STERLING RANCH FILING NO.2

STORM SEWER PLANS

APRIL 2021
SF-20-016

Re: Sterling Ranch Filing No. 2 – 84" Storm Outfall Minimum Pipe Slope Variance Request

Storm Sewer Plan and Profile

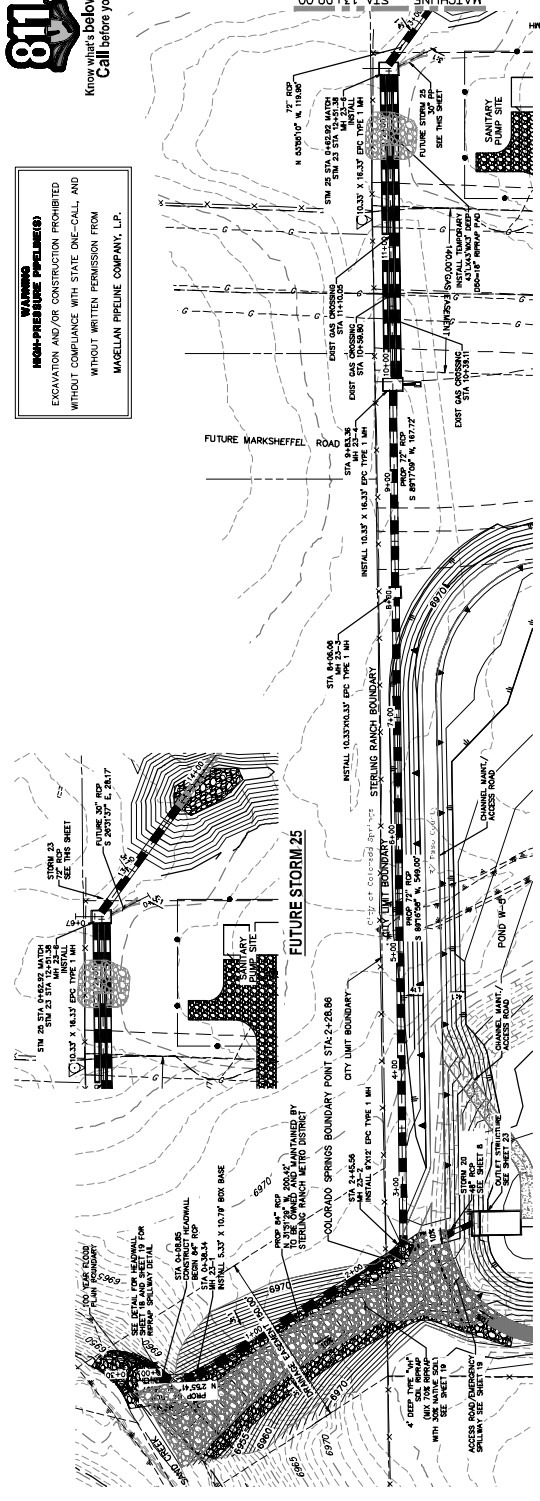
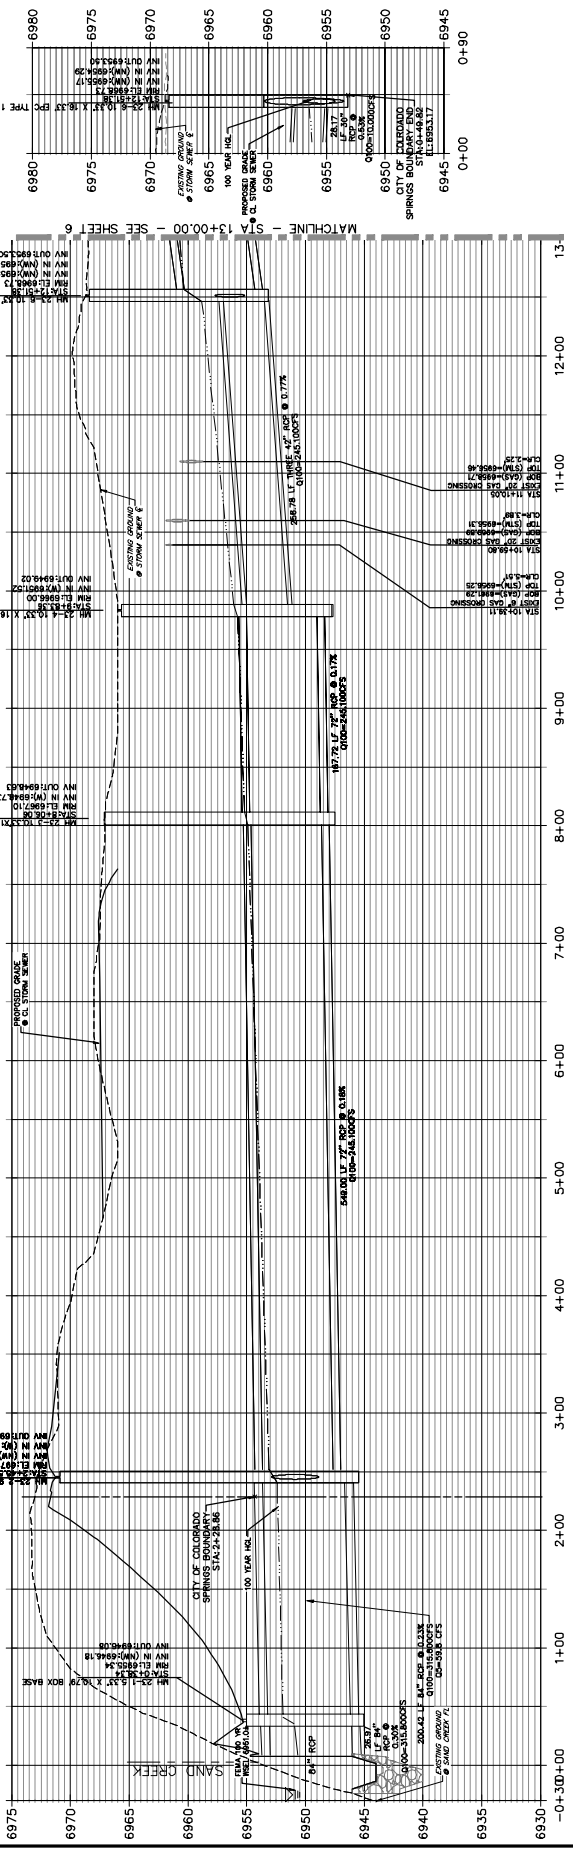
Applicant proposes to utilize a slope of 0.23% in a 200 foot segment of 84" RCP pipe that crosses into the City of Colorado Springs prior to its discharge to Sand Creek.

The variance request is specific to the proposed 84" RCP pipe segment that crosses property within the City of Colorado Springs as it enters Sand Creek as shown on the plan and profile sheet in Exhibit B.

- Per the Hydraulic Grade Line Analysis, the minor storm minimum velocity in this segment is 5.79 feet per second which is above the accepted self-cleaning velocity of 3 feet per second. See Exhibit C
- The slope is controlled by an upstream petroleum pipeline constraint operated by Kinder Morgan.
